Product hierarchy no. *			Part no.	SBU	Type / Description	Customer part no.
SBU PG	PGU	Type				
02	005	017	0000001301	See list below	Power Entry Module	EF11

New internal wiring.

EF11					0118.2262	
creation date	created by	release date	released by	notification no.	revision	page
2015-01-19	huberth	2015-08-05	huberth			1 of 2

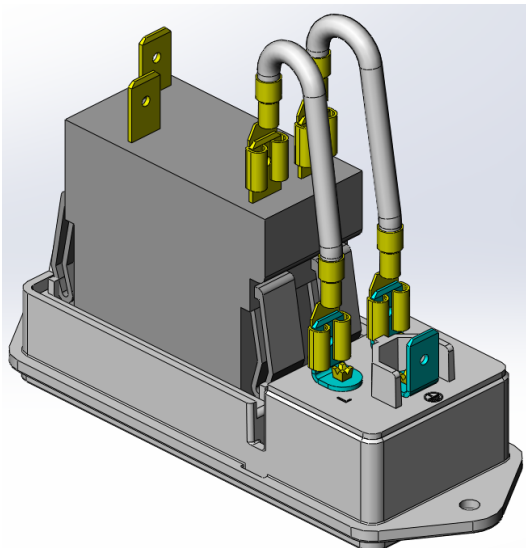
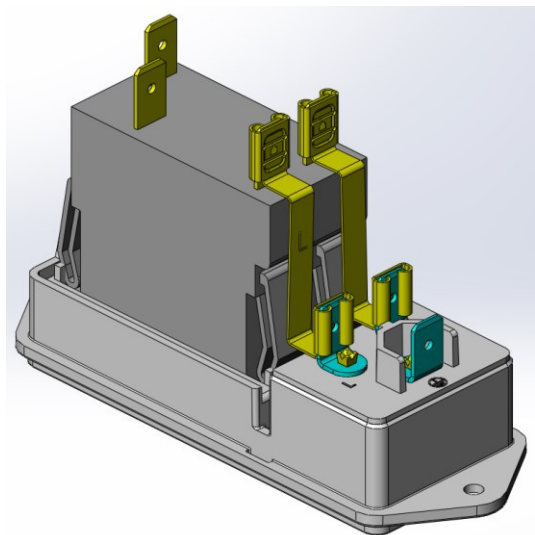
Stranded wire jumper between connector and circuit breaker replaced by a solid jumper.

Old version:

New version:

Reducing the installation depth and harmonization with other power entry modules with circuit breaker TA45.

Form: Yes New connection on back side, reduced installation depth.
Fit: Yes The installation depth is reduced by approx. 20 mm.
Function: No This is a non-functional change.
Production Site: No There is no change of the production site.
Product Label: No There is no change on the label.
